**MAINE DEPARTMENT OF
INLAND FISHERIES AND WILDLIFE**

ADDENDUM NO. 1

**IMPROVEMENTS AT GRAND LAKE STREAM STATE FISH HATCHERY
GRAND LAKE STREAM, MAINE**

BGS PROJECT NO.: 3289-14

LOWER PAVILION SECTIONS

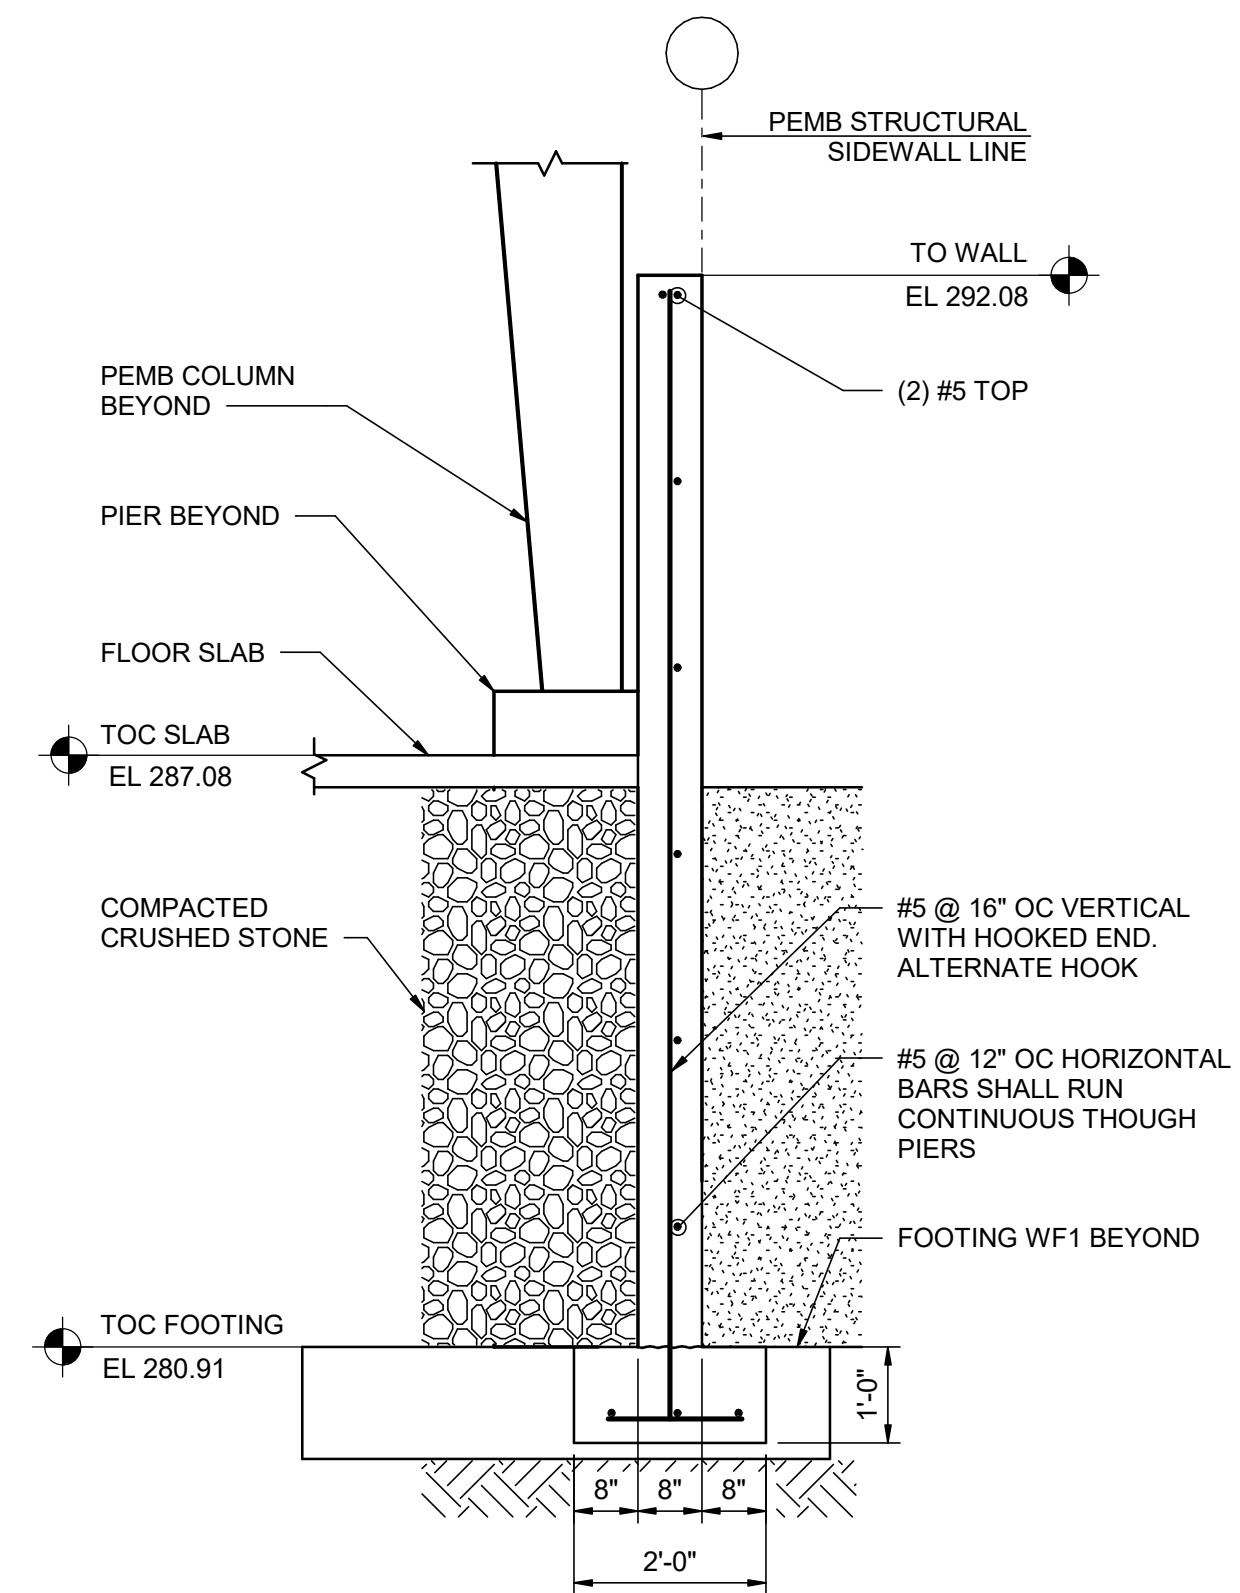
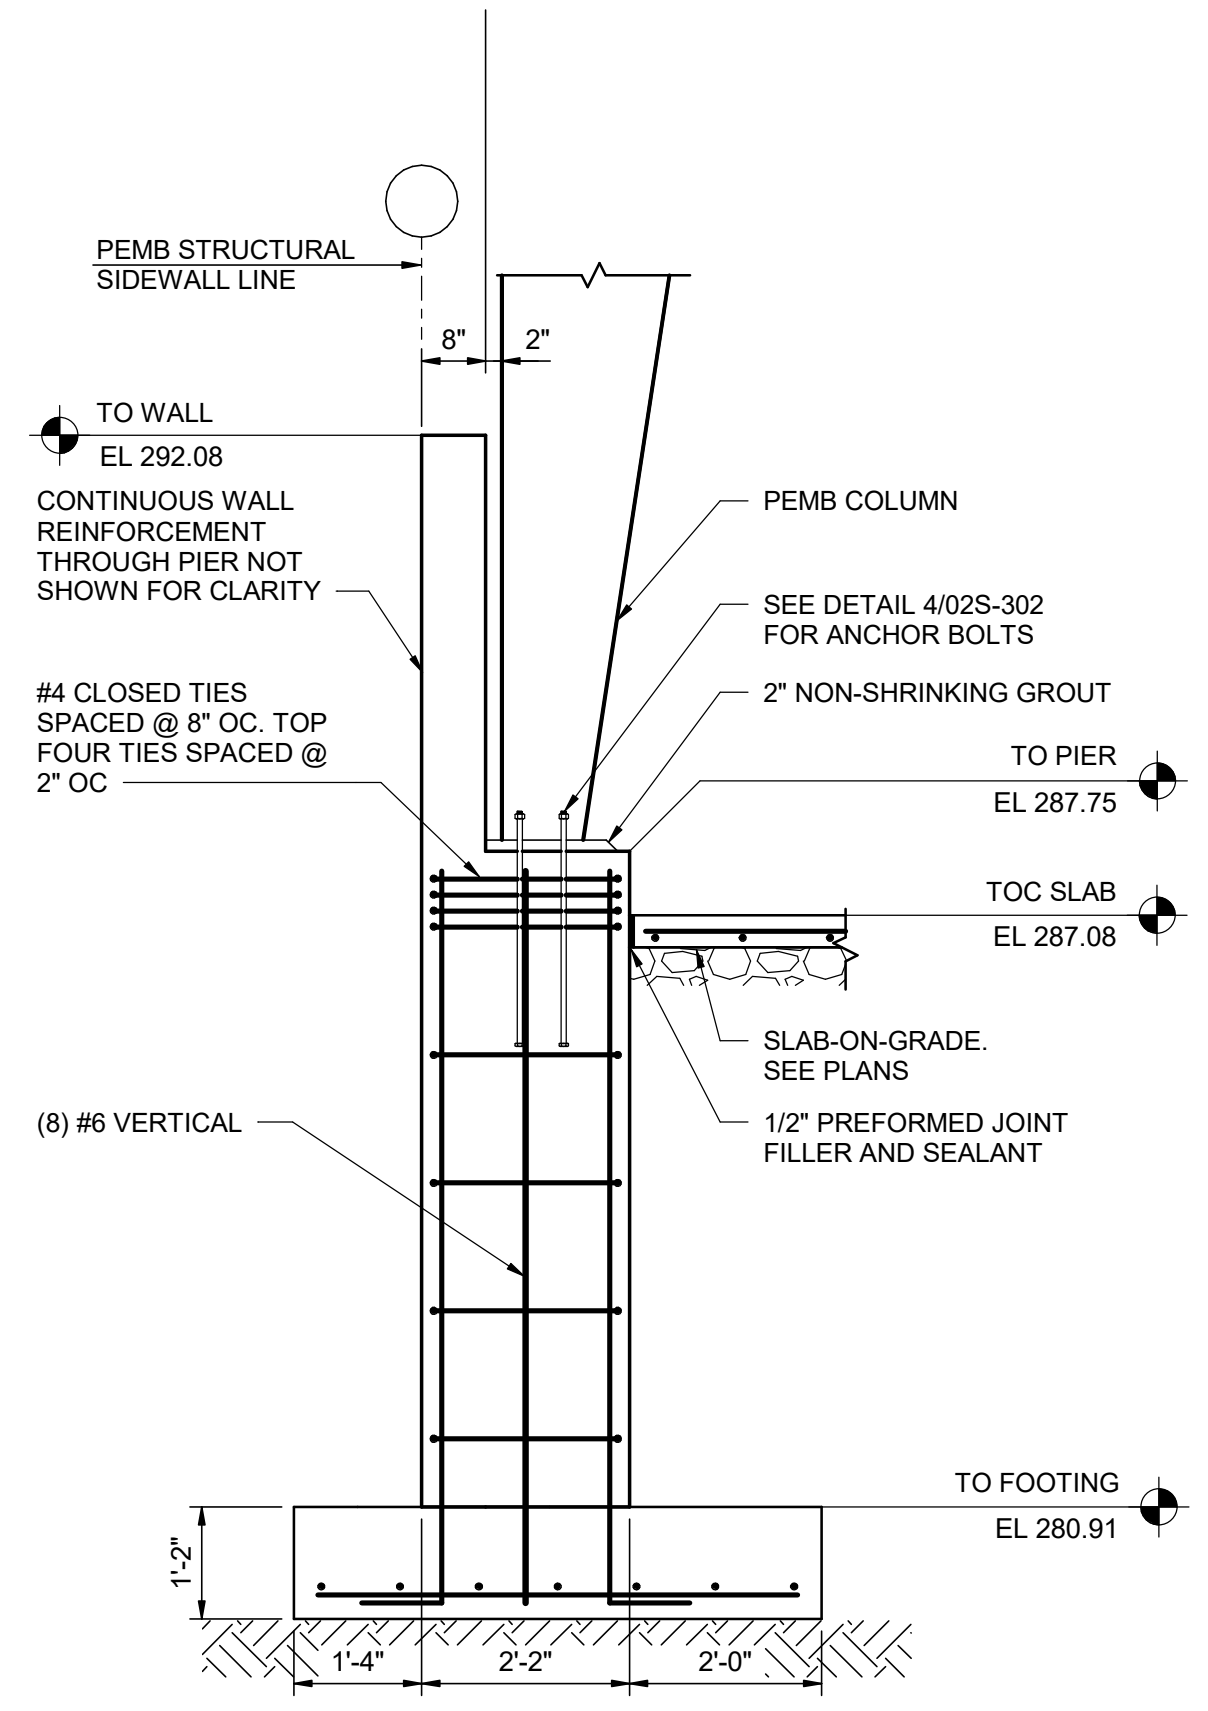
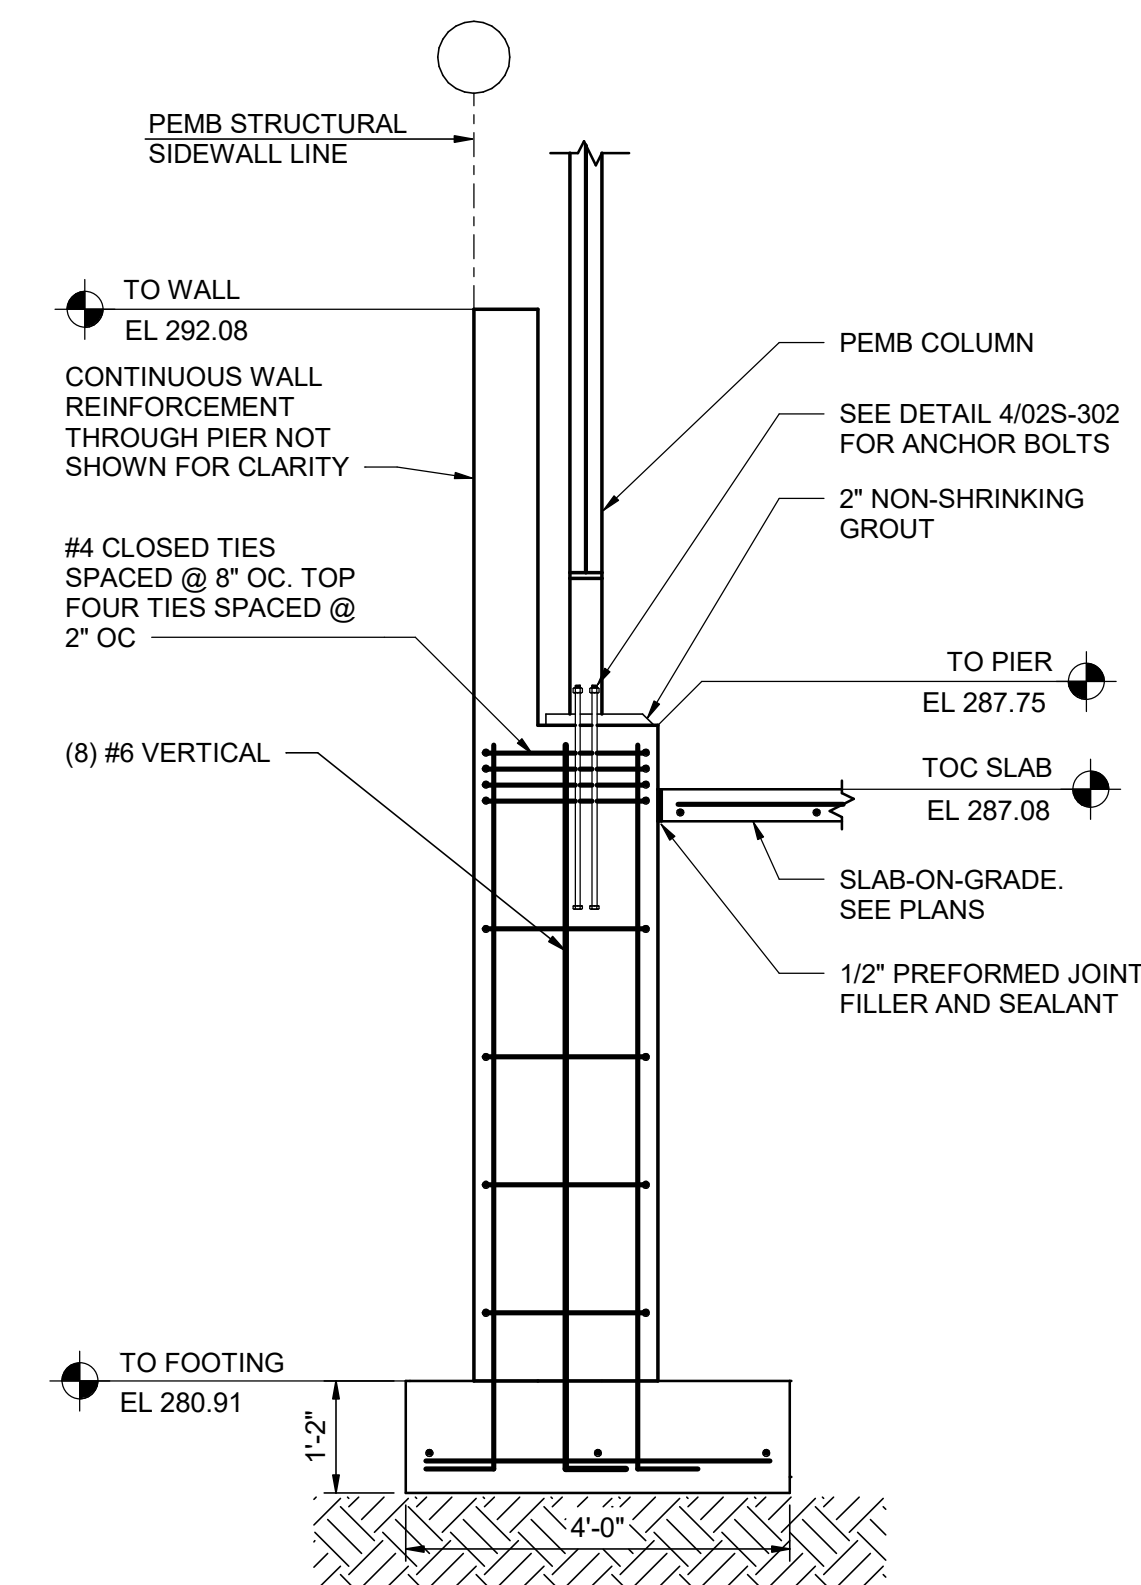
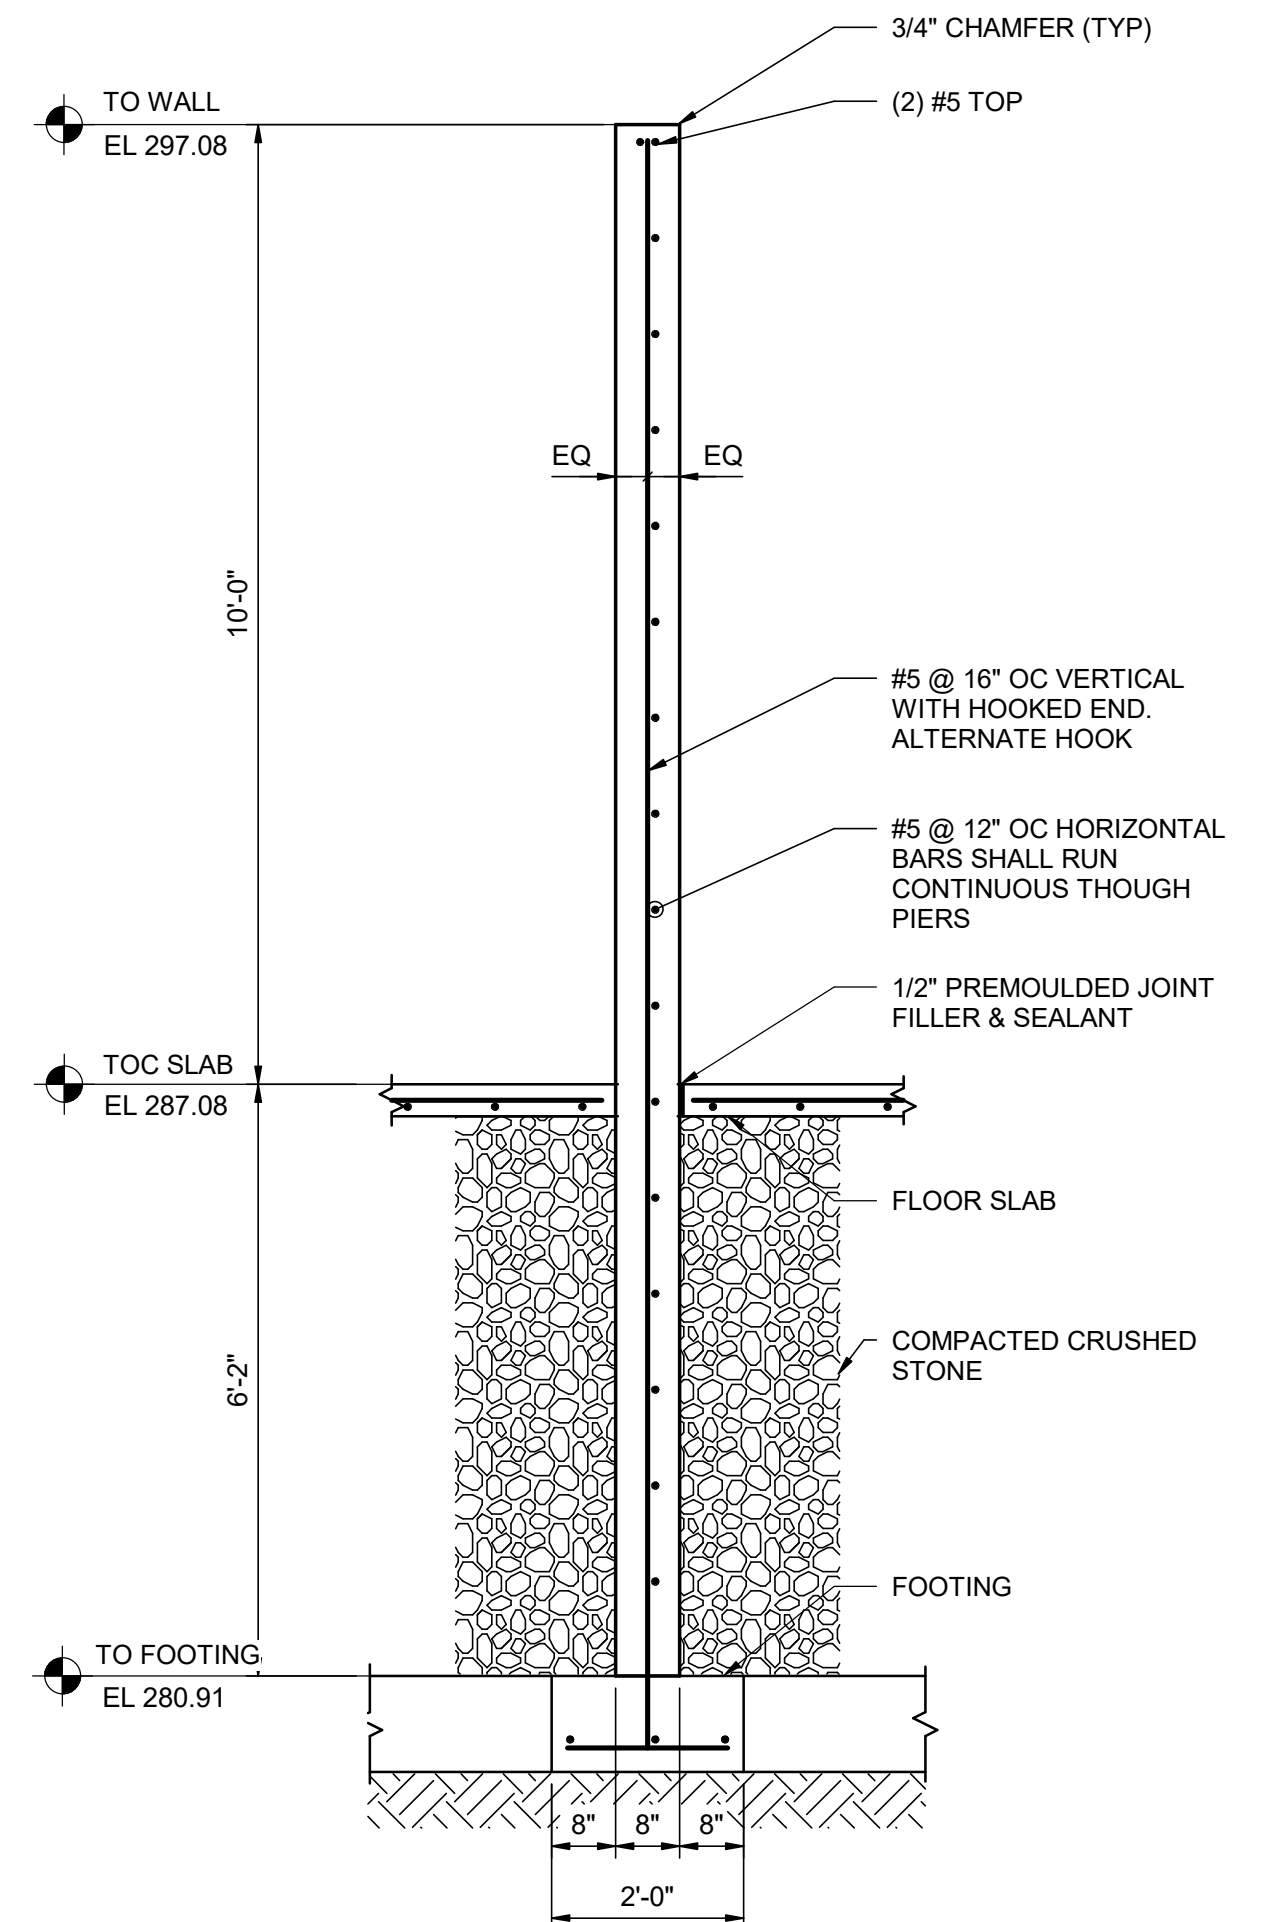
***UPDATE:** Sheet was added to set.*
